**RESPONSE TO REQUEST FOR FURTHER INFORMATION – DA79/2022**  
**1-5 CANBERRA AVENUE, 2-8 HOLDSWORTH AVENUE, AND 4-8 MARSHALL AVENUE, ST LEONARDS**

This letter has been prepared by Ethos Urban on behalf of Evergreen in response to Council's request for further information letter dated 26 August 2022. The Development Application (DA) relates to the construction of three new residential flat buildings at 1-5 Canberra Avenue, 2-8 Holdsworth Avenue, and 4-8 Marshall Avenue, also known as Area 1, 2 and 4 of the St Leonards South Precinct (the site).

**Figure 1 Development Analysis for 2 Marshall Avenue**

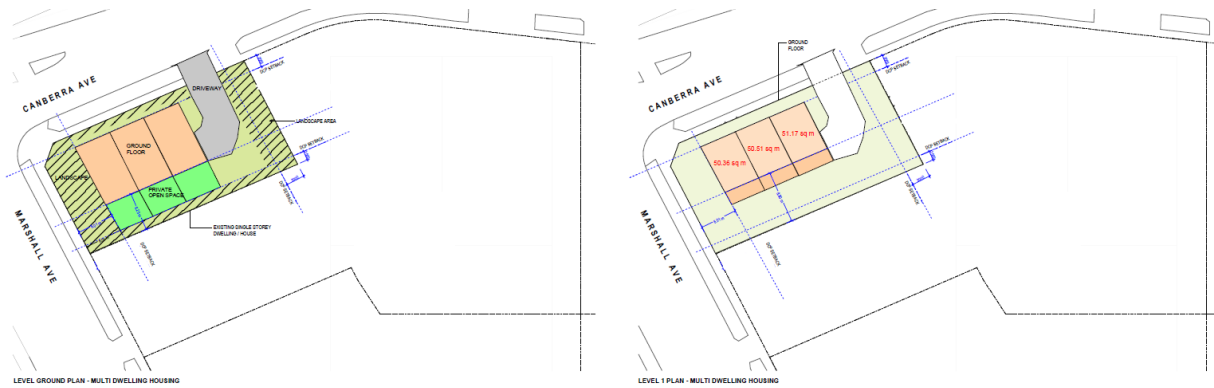
Although not directly requested by Council, the proponent and project design team have undertaken an analysis of 2 Marshall Avenue to further address the Land and Environment Court site isolation planning principle and to determine potential development options on the site in the future.

Although the Lane Cove DCP requires a minimum site area of 1,000m<sup>2</sup> for a multi-dwelling housing development, the analysis undertaken by Rothe Lowman at **Attachment C** has determined that a small-scale multi-housing development of up to three dwellings can be appropriately accommodated on the site, despite the non-compliance with the site area. This is considered an appropriate hypothetical development outcome for the site given:

Indicatively, each dwelling will be three storeys, with basement carparking and an undercroft area. The dwellings will have an approximate GFA of 114m<sup>2</sup> and is capable of achieving a high level of amenity. As per the analysis undertaken, it is confirmed that the development would comply with the relevant setback controls and landscape area identified under the Lane Cove DCP.

**Figure 1** below illustrates the concept scheme for a small-scale multi-dwelling housing development at 2 Marshall Avenue.
